Access Compliance Report

Public Rights-of-Way

(Curb Ramps)

Intersection ID: 4122	Main Street: DAVID_COX_RD	Cross Street: MALLARD_RIDGE_DR	Location:	N
ADA ID: E260A09479CE	Ramp Type: Perp	Initial Pass/Fail: Fail	Overall Compliance: No	Severity Score: 12.5

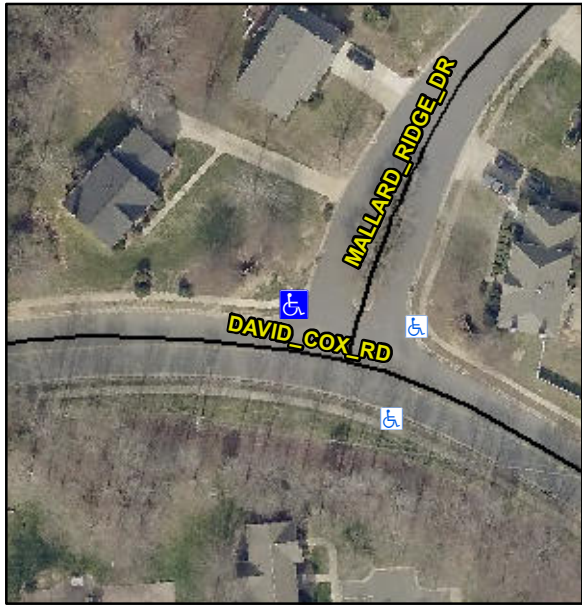
Codes/Mitigation Info/Possible Solution			Field Measurements/Component Compliance					
	Possible Solutions:		Compliance	Description	Data	Compliance	Description	Data
	Remove & Replace Entire Ramp.		N/A	Ramp Length (in)	95.0	No	Ramp Slope (%)	10.6
			Yes	Ramp Width (in)	48.0	Yes	Ramp XSlope (%)	1.9
			N/A	Flare Type LT	N/A	N/A	Flare Type RT	N/A
			N/A	Flare Slope LT (%)	N/A	N/A	Flare Slope RT (%)	N/A
			N/A	Flare Traversable LT?	N/A	N/A	Flare Traversable RT?	N/A
			N/A	Landing Length (in)	N/A	N/A	DWS Provided?	N/A
			N/A	Landing Width (in)	N/A	N/A	DWS Contrast?	N/A
			N/A	Landing Slope (%)	N/A	N/A	DWS Length (in)	N/A
			N/A	Landing X Slope (%)	N/A	N/A	DWS Full Width?	N/A
Surveyor Notes:		N/A	N/A	Landing Curb? (Y/N)	N/A	N/A	DWS Offset (in)	N/A
PROW/ADA:		R304.2.2	N/A	Shared Landing?	N/A			
			N/A	Gutter Ponding?	N/A	N/A	Gutter Slope (%)	N/A
			N/A	Gutter Lip Ht (in)	N/A	N/A	Gutter X Slope (%)	N/A
			N/A	Painted X Walk1?	No	N/A	Painted X Walk2?	N/A
